PLANNING AND ZONING COMMISSION SITE PLAN SUBCOMMITTEE

Re: P.Z. 14-98 Dierbergs Wildwood Town Center – Building G's Drive-Through Facility

AMENDED SITE DEVELOPMENT PLAN
DIERBERGS WILDWOOD

Re: Preliminary Site Development Section Plan for the Addition of a Drive-Through Facility on Outlot G –
Dierbergs Wildwood Town Center

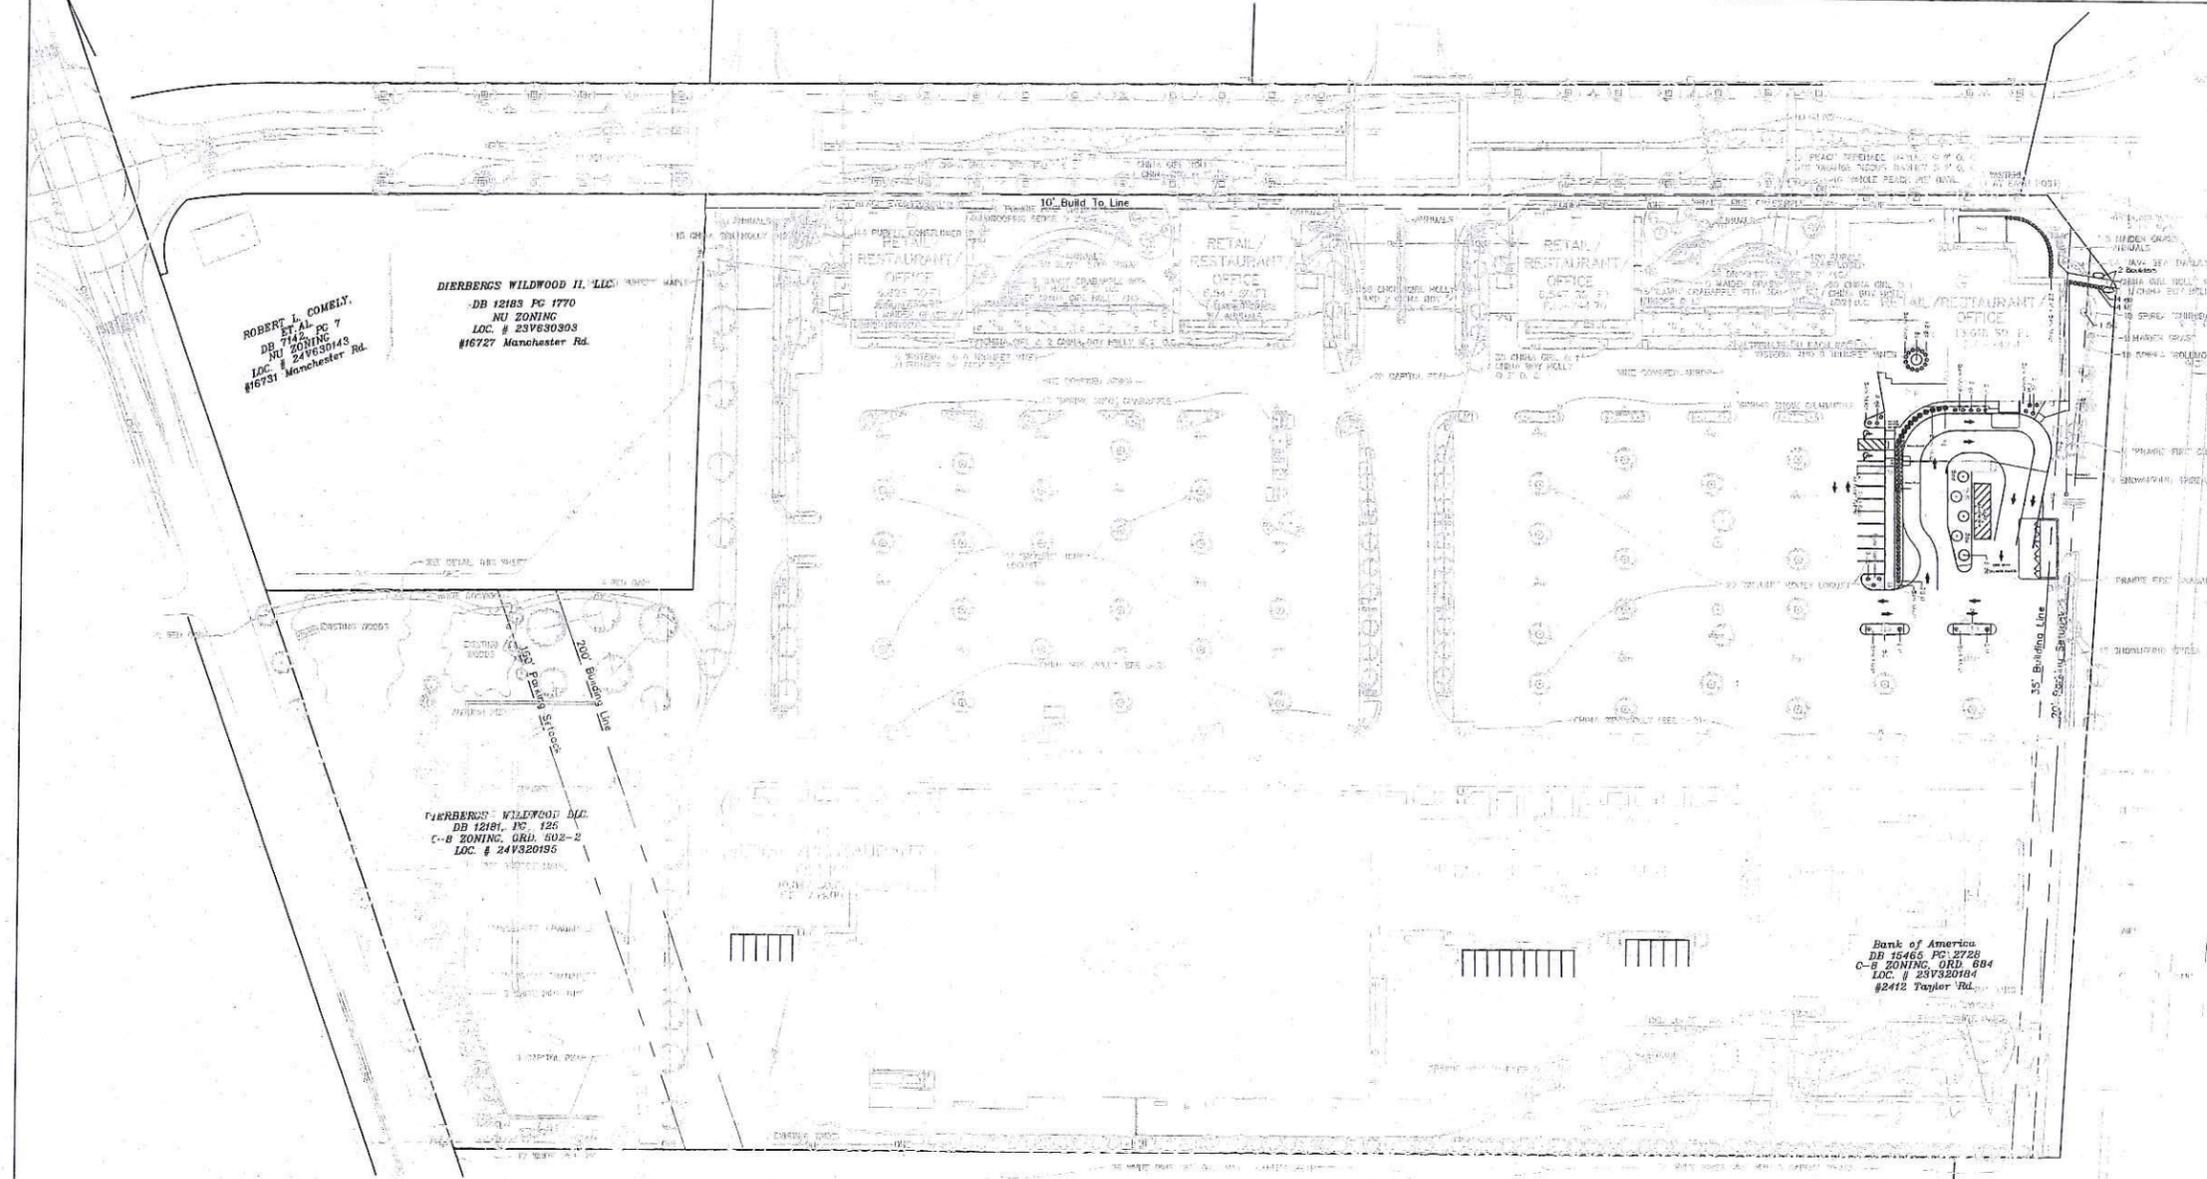
1. Please indicate on the plans the amount of outdoor seating, in addition to any fencing and landscaping, in association with the new patio area located to the west of the building along Taylor Road.

2. Please identify the escape lane in the drive-through as such.
3. Please show the curbed section in the middle of the drive-through lanes as a planter area.

4. Please increase the size of the pads in front of the trash dumpsters to match the length of the trucks that will service them.
5. Please provide information on the pedestrian circulation patterns to and from the trail area, Taylor Road, the parking area, and the new patio area.

6. Please relocate the sidewalk connection to the trail from its current proposed area on the north side of the building. At its current location, pedestrians coming to the restaurant from the trail system will be funneled into the drive-through lane.

7. Please relocate the required pedestrian access to the trail further to the south, where the new islands are proposed. This change will require revisions to the curb at the entrance of the drive-through lane, as well as the islands in the parking lot to be ADA accessible.

8. Please provide updated parking calculations for this development, taking into account the new use, as well as the additional patio seating.
9. Please identify if the area on the northeast corner of the building is an employee-only entrance. The Department, again, has concerns with the proposed handicapped access and pedestrian connection directly accessing into the drive-through lane.

10. Please provide a minimum of two (2) bicycle racks in the vicinity of the use for parking purposes.
11. Please provide a Landscaping Plan.
12. Please provide a Lighting Plan, in compliance with the City's Outdoor Lighting Requirements.

SITE DEVELOPMENT LANDSCAPE PLAN
DIERBERGS WILDWOOD
TAYLOR ROAD WILWOOD, MISSOURI

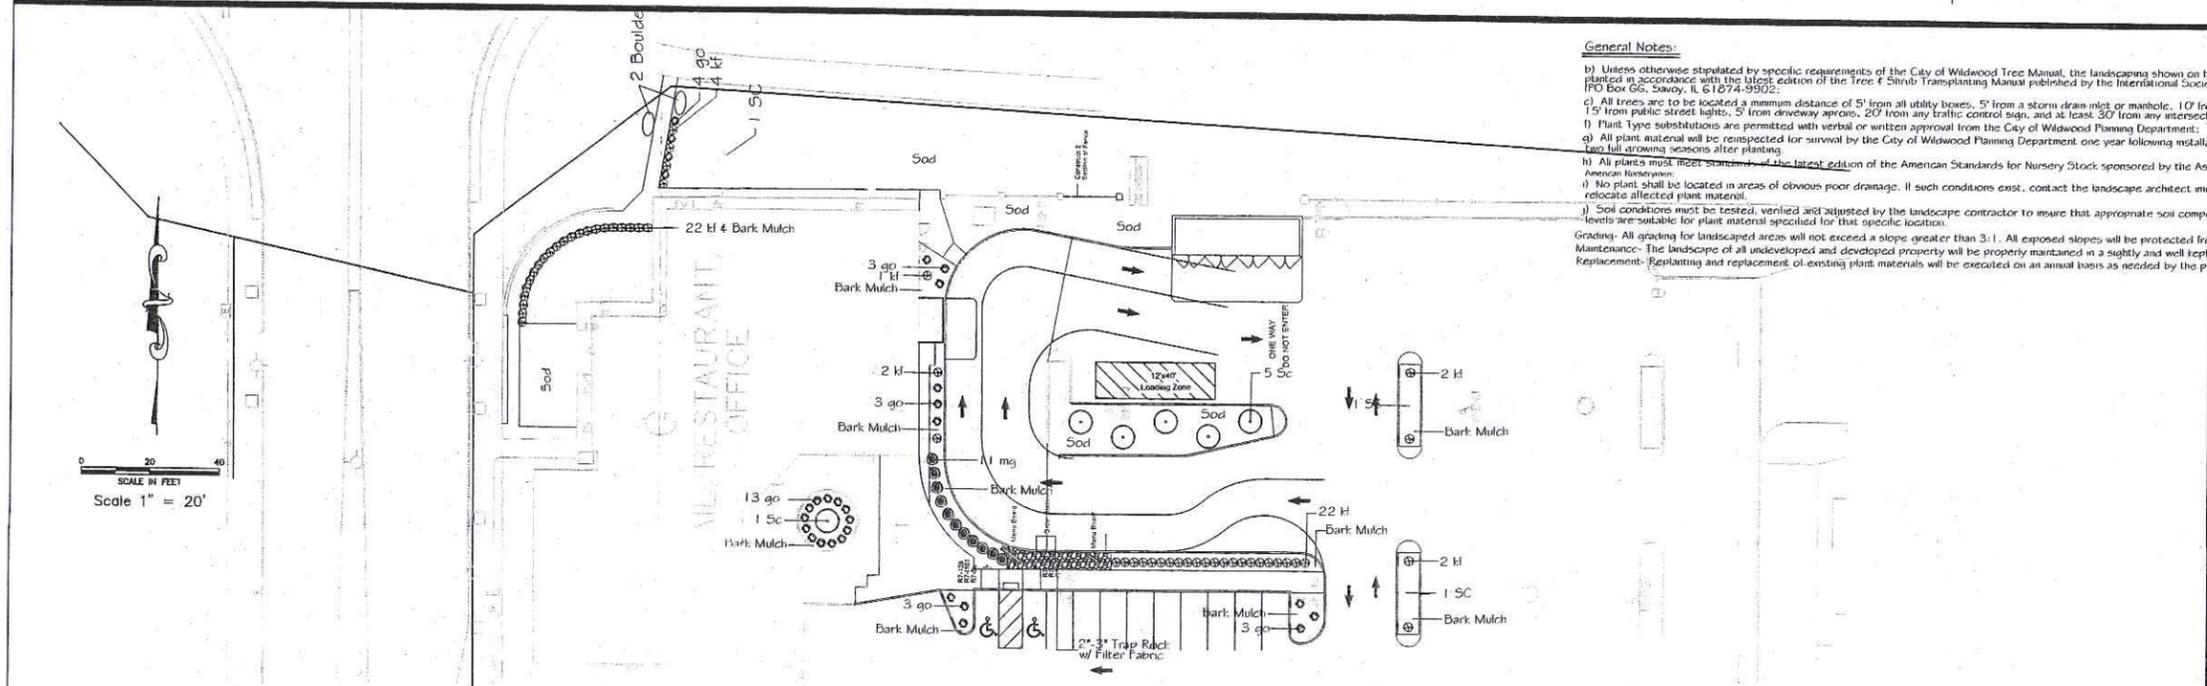
We have reviewed the landscape plan prepared by Waldbart and Sons Nursery, dated 3/28/16 and find that the landscape development proposed for this project does not meet the minimum requirements set forth in the City's Ordinances and Tree Manual/Sustainable Plantings Guide.

- Planting Details
- General Notes b,c,f,g,h,i, and j from the Landscape Plans section of the Tree Manual
- The following notes from the Landscape Applications section of the Tree Manual
 - Grading - All grading for landscaped areas will not exceed a slope greater than 3:1. All exposed slopes will be protected from erosion as needed.
 - Maintenance - The landscape of all undeveloped and developed property will be properly maintained in a sightly and well-kept manner.
 - Replacement - Replanting and replacement of existing plant materials will be executed on an annual basis as needed by the property owner.

Since this project is the redevelopment of a small portion of a larger, existing commercial center, much of the required landscape is in place. It appears that a section of existing parking and some associated landscape islands are being removed and replaced with new drive thru lanes and landscape areas.

While the proposed plants are hardy in the St. Louis area, the landscape design leaves a lot to be desired. Two thirds of the new material consists of two types of ornamental grasses, which only look great for 50% of the time. Used in conjunction with other plant types, ornamental grasses add interest and diversity to the landscape. It is our recommendation that a more varied plant pallet be employed. Tall evergreen shrubs might be considered in lieu of the maiden grass to help screen the drive thru area from the main entrance, and the long strings of feather reed grass might be reconfigured to include other plants that exhibit different colors, sizes and textures. In addition, it is our recommendation that the 9 to 10 existing shade trees that are to be removed to accommodate the new improvements be replaced with similar species in the newly created islands and planting areas to match the existing pattern within the larger parking area.

1 5-11-10 MCH Replace 6 GO with 3 SC

The section in question are the comments recommending different planting materials. In our experience the Karl Foerster and Maiden Grass look good for more than 50% of the time as we do not cut them until late February or early March. We prefer the manner in which they provide screening, as they are not as full as a tall evergreen shrub and allow some line of sight opportunity for pedestrians and vehicles in the drive lane (we believe this gives a better sense of security to the public than completely screening them with a material such as a tall evergreen). Furthermore, we have great experience with the longevity and hardiness of this type of material in a commercial setting. The other primary planting (Grey Owl Juniper) will add good color to the new area and is also a hardy material. All of the plantings we are adding are very close to drive lanes and sidewalks and will have a high concentration of salt content in the soil. Unfortunately, this high salt content cannot be avoided in these areas and hardy planting materials need to be installed accordingly to prevent constant turnover of materials. With respect to the trees, we are removing approximately 9 trees and will be adding 6 trees (primarily in the island by the new loading zone). We specifically omitted adding trees to the new landscape islands immediately east of the drive-thru lane to keep a good line of sight distance for vehicular traffic exiting the drive-thru.

We respectfully request to keep the proposed plantings as indicated on our landscape plan based on the above information. Although we are only modifying a small portion of the overall development, we believe the proposed plantings will complement the existing center landscaping. Please review with Terraspec and let me know if you have additional questions or would like to discuss in greater detail.

Calculation Summary

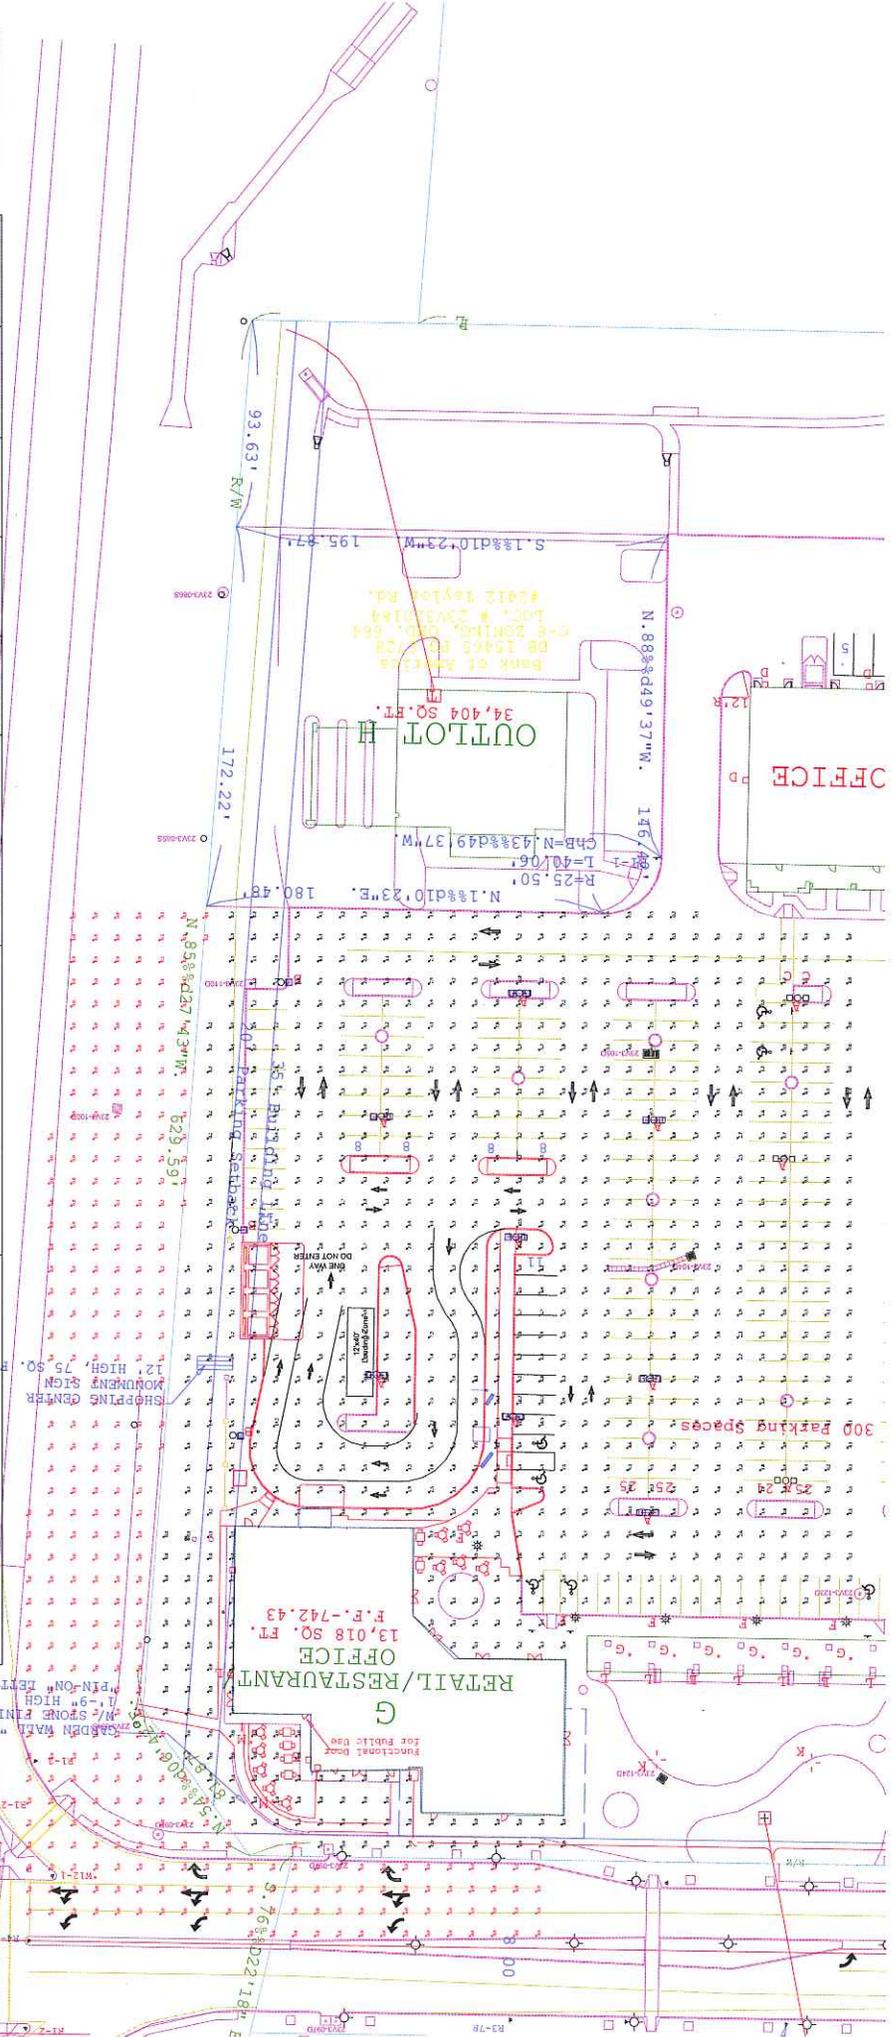
The photometric plan provided by the Dierbergs representative is incomplete from several perspectives; therefore, it is difficult to determine if the lighting is satisfactory.

1. The illuminance plan shows, at least, partial horizontal illumination values in the proposed location of the drive-up location. However, it does not include lighting impact from any proposed building mounted lighting or other lighting specific to the drive-thru. What is reviewable has some issues. Average illuminance is greater than recommended and uniformity ratios are sub-standard. (See “Dierbergs Lot Comments”)

The illuminance plot shared, showing updated values based upon a change to LED fixtures, indicates sub-standard lighting (light levels are too high and poor uniformity). If this is proposed it should not be accepted and should be reworked. Additionally, the illuminance plot does not indicate vertical illuminance at the property line.
